**AREA 3 FIELD SAMPLING PLAN**  
**ADDENDUM TO REMEDIAL INVESTIGATION**  
**WORK PLAN**  
**FOR PER- AND POLYFLUOROALKYL SUBSTANCES**  
**(PFAS)**

**FORMER FORT DEVENS ARMY INSTALLATION, DEVENS, MA**

**JULY 2020**

Figure  
7

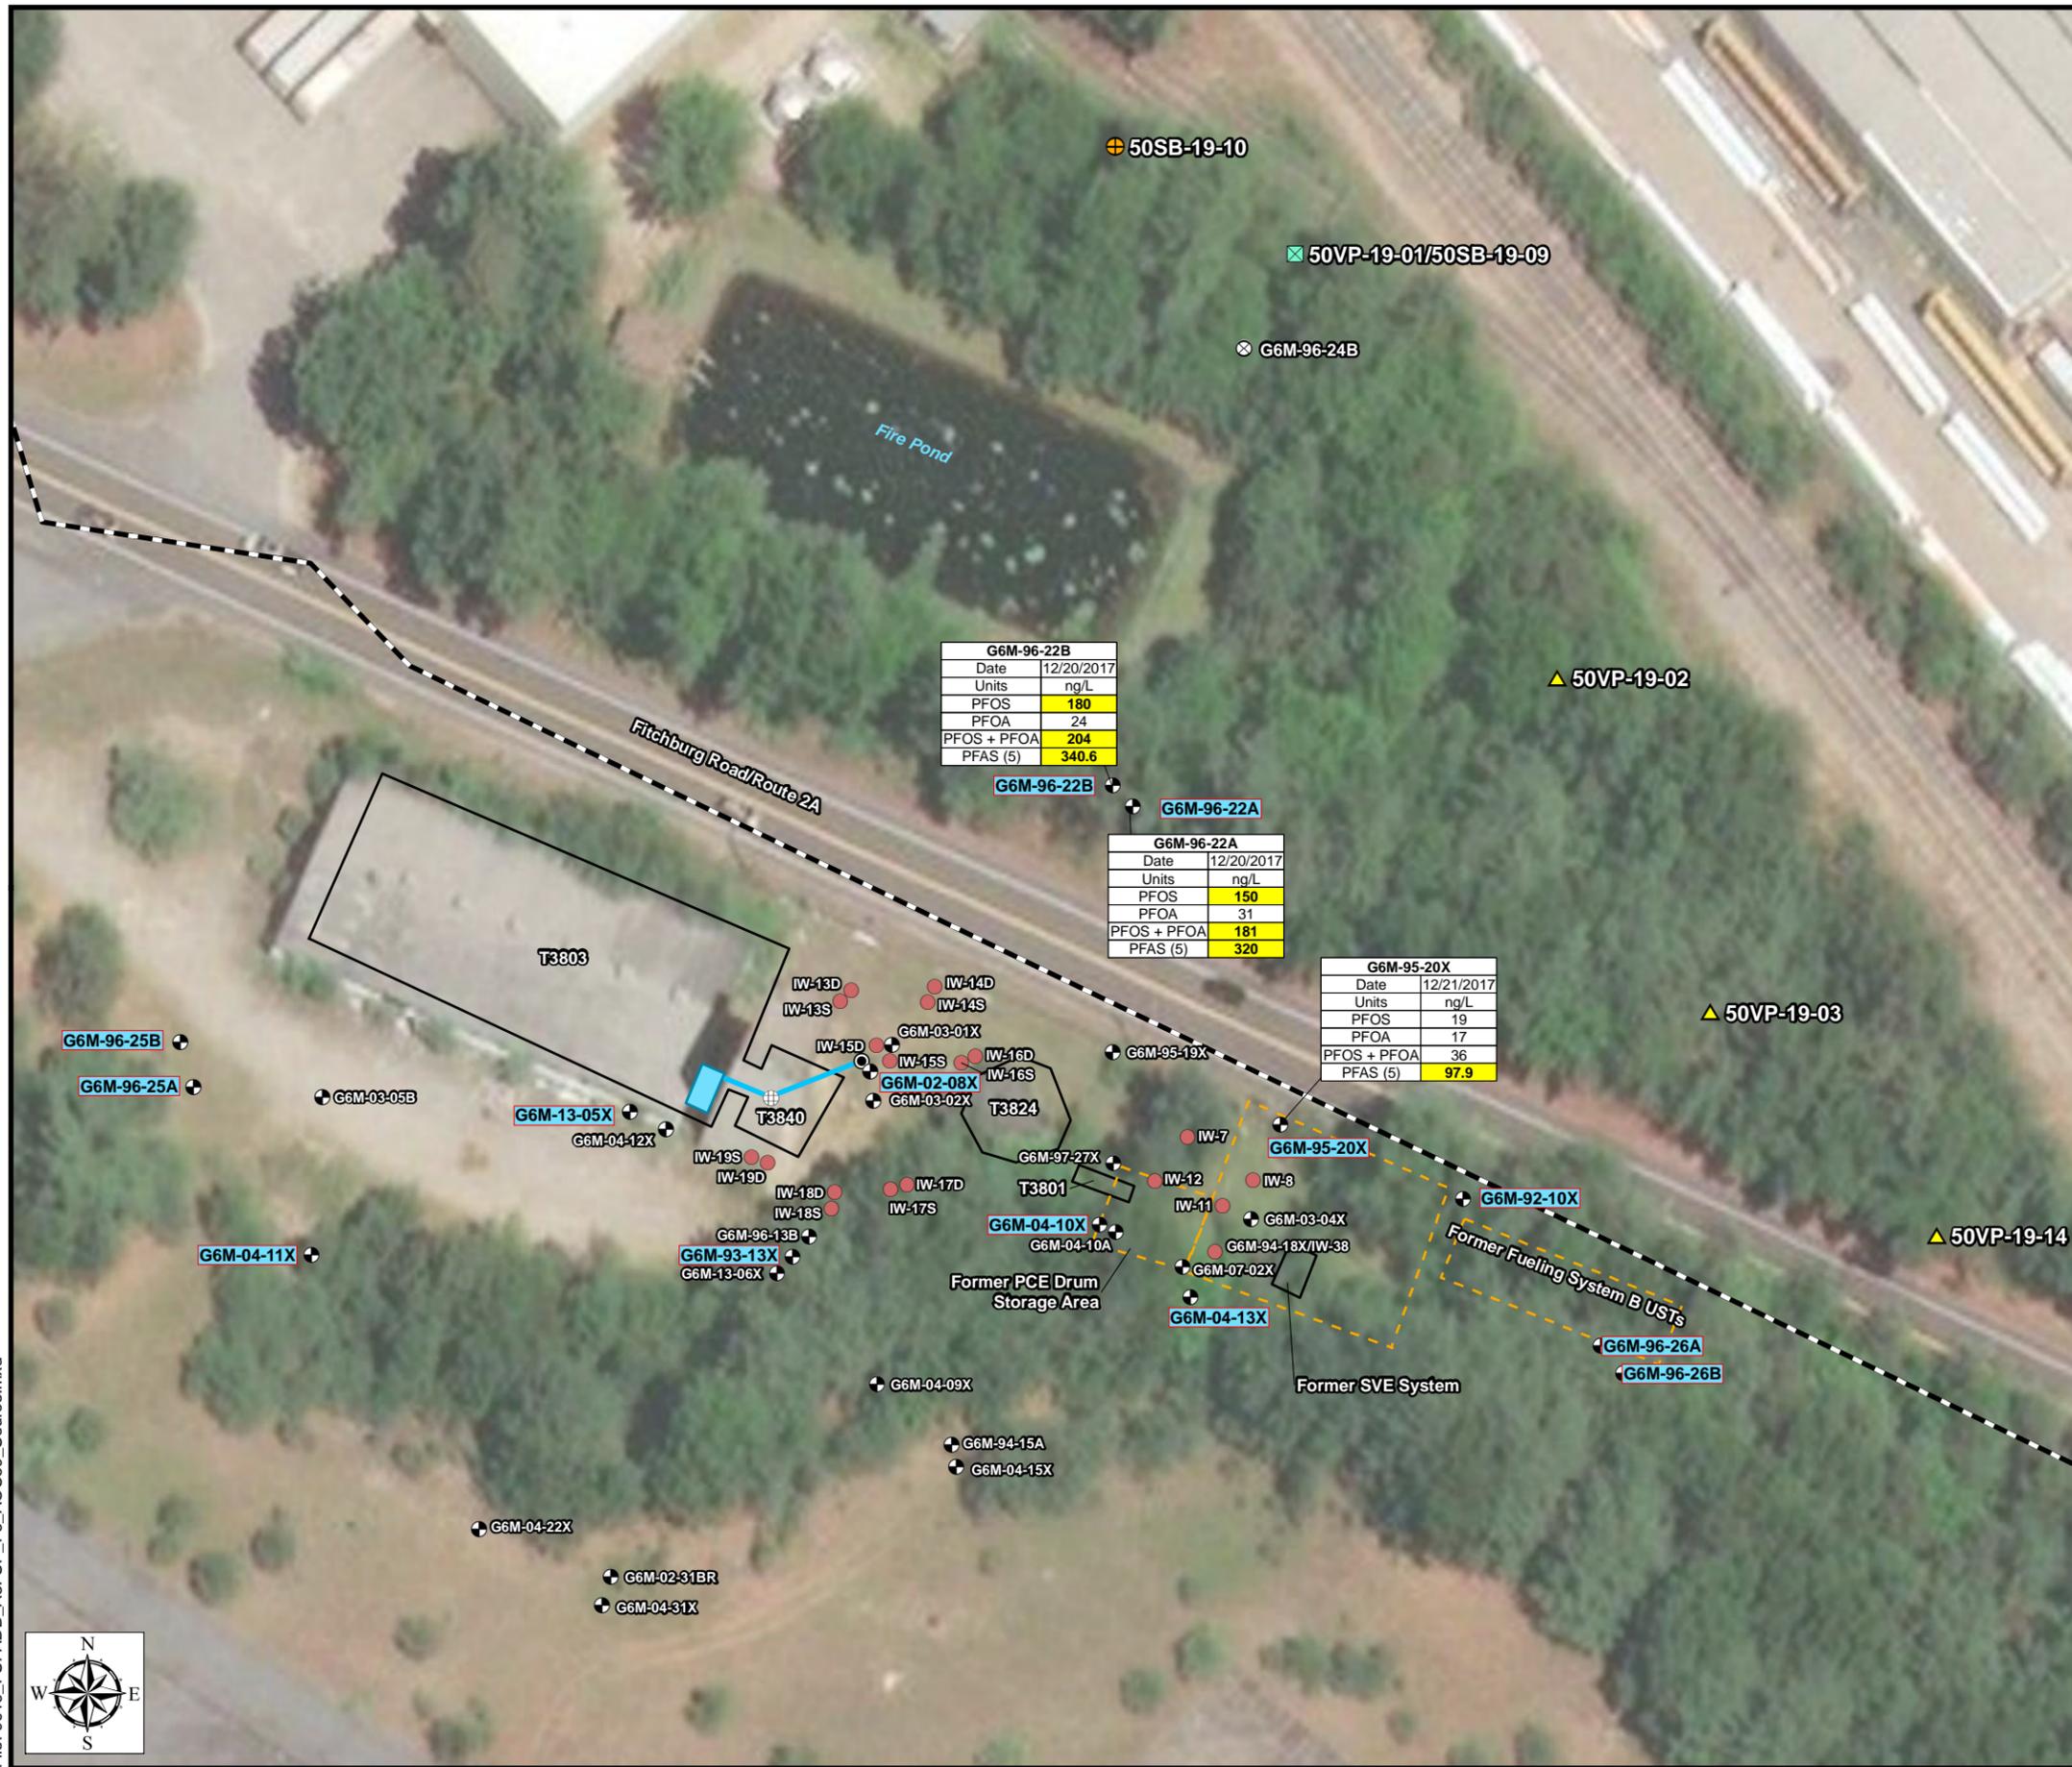
26. Figure 7 – EPA disagrees with the groundwater flow direction as depicted on this figure; Additional piezometers are recommended to more accurately define groundwater flow direction on the western side of this site, including areas west of AOC50-17-01 and AOC50-17-03. There are also an inadequate number of soil samples with samples at the water table in areas of elevated PFAS concentrations.

**Comment #5:** Figure 7: The proposed scope of investigation is insufficient to characterize groundwater in the vicinity of the fire station and northern aircraft hangar (Building 3818). As demonstrated by the conditions encountered at the Main Post fire station, the airfield fire station should be assessed as a potential independent PFAS source area. To accomplish this, groundwater flow directions beneath the fire station must be determined and PFAS concentrations upgradient, downgradient, and vertically within the aquifer must be determined to pin-point source locations, target soil samples, and determine the contribution of fire station source(s) to more extensive contamination that may originate at upgradient locations (e.g., the aircraft hangars). As indicated in Section 5.2.1 (and discussed during the October 11 conference call), groundwater flow directions beneath the fire station are not known, and available data are not sufficient to determine if the PFAS contamination reported in samples collected from locations AOC50-17-01 and AOC50-17-02 originates from a source near the fire station or an upgradient source (e.g., the aircraft hangars). In addition, existing water level control points are insufficient to determine groundwater flow directions beneath the northern aircraft hangar, a probable PFAS source area. To close these datagaps:

**SC Comment #11:** Figure 7 – (Airfield Fire Station.) Consider moving proposed locations 2 and 3 west/southwest of AOC50-17-01 and AOC50-17-02. The gradient is likely west/southwest in this area; therefore, installing wells/piezometers west of these locations, where elevated PFAS concentrations were detected, will help characterize extent of PFAS as well as refining the gradient. Further, the plan should identify well screen intervals (depths/elevations and target water-bearing strata) of the piezometers or monitoring wells and provide some rationale for those intervals based on the depths where PFAS are encountered.

**SC Comment #12:** Figure 7 – (Northern Aircraft Hangar – Building 3818.) The plan should identify well screen intervals (depths/elevations and target water-bearing strata) of the piezometers or monitoring wells and provide some rationale for those intervals based on the depths where PFAS are encountered.

**SC Comment #13:** Figure 7 – Consistent with previous comments, it is suggested that additional transects of vertical-profiling points be advanced, roughly perpendicular to the likely hydraulic gradient, to site locations and depth intervals of additional permanent monitoring wells or piezometers.

**Comment 22. Figure 7** - Vertical profiling locations are needed southwest of the former fire station to identify PFAS contamination separate from the downgradient detections near the fire training area. Additional borings are also needed in the vicinity of the former fire station because a local PFAS source is indicated by the elevated PFAS concentrations in groundwater. A more comprehensive investigation around buildings 3813 and 3818 is warranted based on the elevated PFAS concentrations detected in groundwater at these two buildings. The magnitude of the concentrations suggests a local source rather than an upgradient source. Soil borings and vertical profiling is warranted.

**Comment 2.** Figure 7: The scope of the proposed investigation is insufficient to determine whether the airfield fire station is an active source of PFAS contamination in groundwater, and the scope of the proposed investigation is insufficient to characterize groundwater impacted by PFAS releases from the two aircraft hangars. Significant datagaps will exist if site-specific groundwater flow directions, upgradient and downgradient PFAS concentrations, and the vertical extent of contamination at the fire station and hangars are not determined. The Army is aware of this concern, and has responded previously (e-mail dated October 1, 2019), indicating that the proposed work may be sufficient to characterize these areas. MassDEP disagrees for the reasons given previously (e-mail dated December 7, 2018).

**Comment 12. Figure 7** – Add G6M-04-04X for monitoring (shade blue) and for better groundwater flow characterization.

**Comment 13. Figure 7** – Add a vertical profile and piezometer downgradient of the fire station within the grassy area between the flightlines.

Background Surface Water Body Sample Locations Devens PFAS RI WP - Area 3 FSP Addendum		
Former Army Installation Devens Devens, Massachusetts		
<b>KOMAN Government Solutions, LLC</b> 293 Boston Post Road West, Suite 100, Marlborough, MA 01752		
0    2,000    4,000 Feet	Date: 01/16/2020	Figure 8

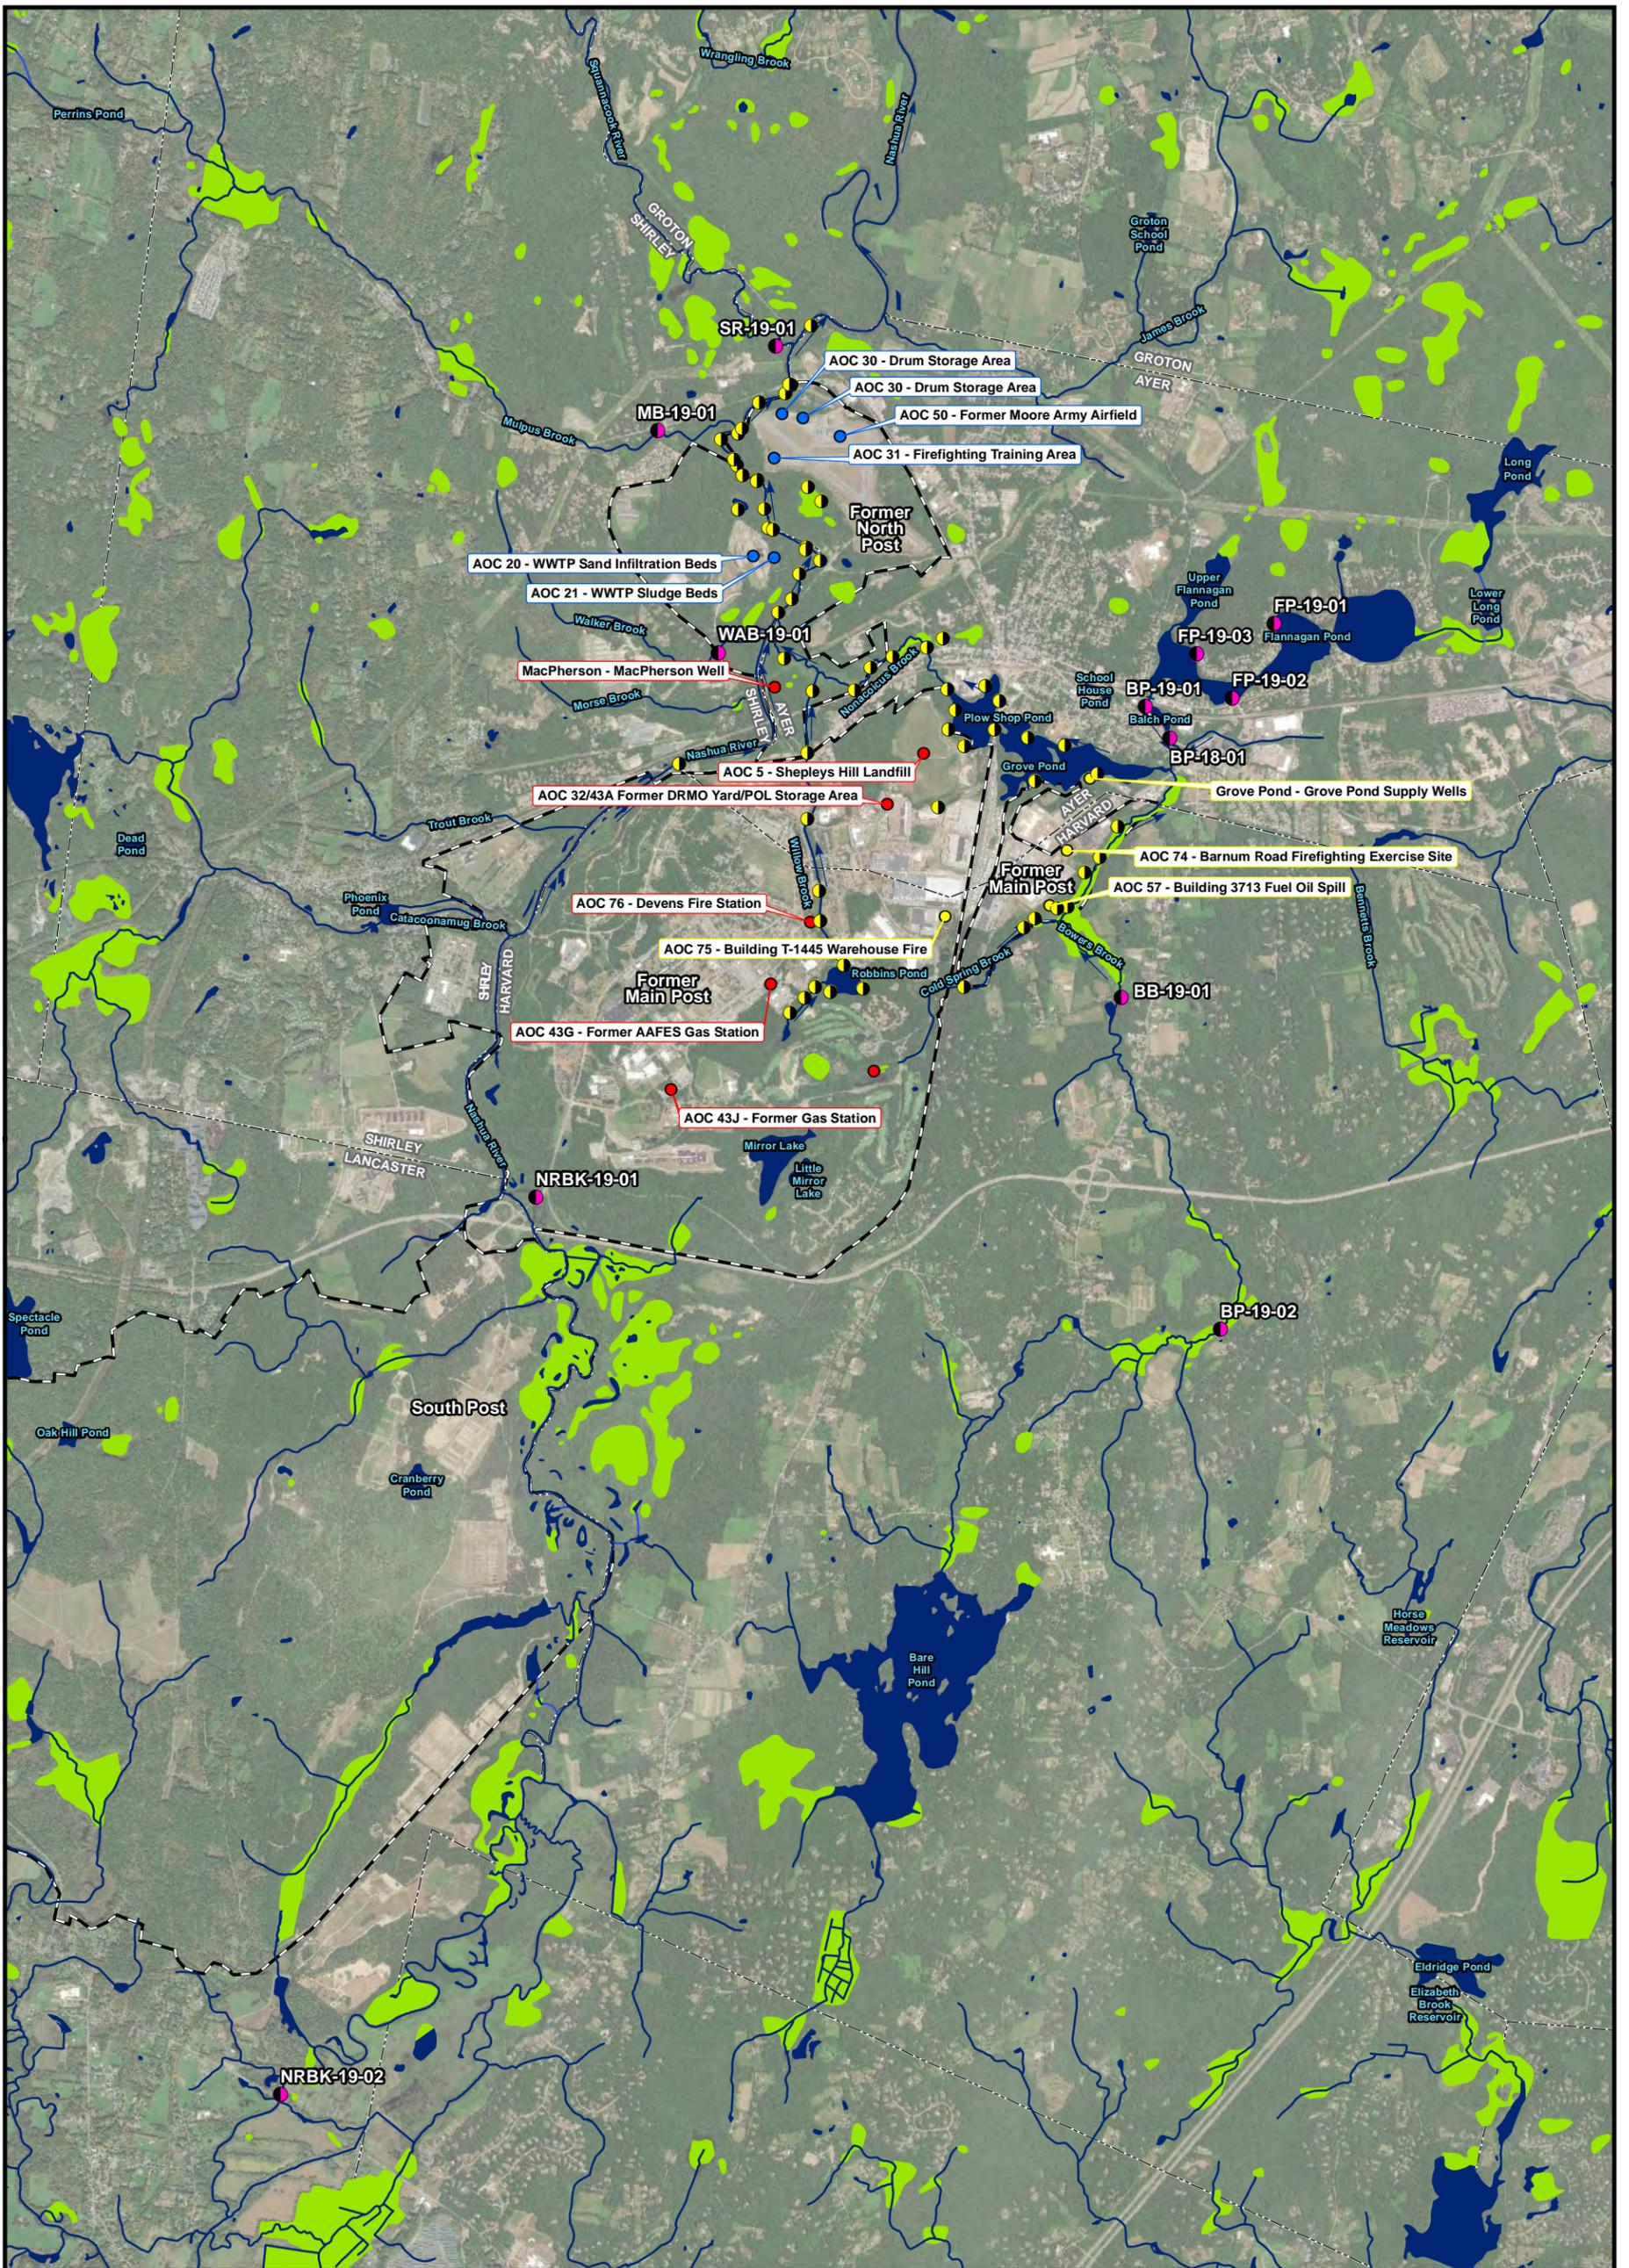
Please note that additional surface water and sediment samples will be collected as part of the PFAS RI at Devens and are located within various surface water bodies that are situated topographically and hydraulically upgradient of the former Main Post and North Post. The locations of upstream surface water and sediment samples are shown on a newly added Figure 8 (attached) and incorporated into Table 11 of the Area 3 FSP.

A surface water and sediment sampling location was added to Bowers Brook. Table 11 and Figure 8 have been updated accordingly.
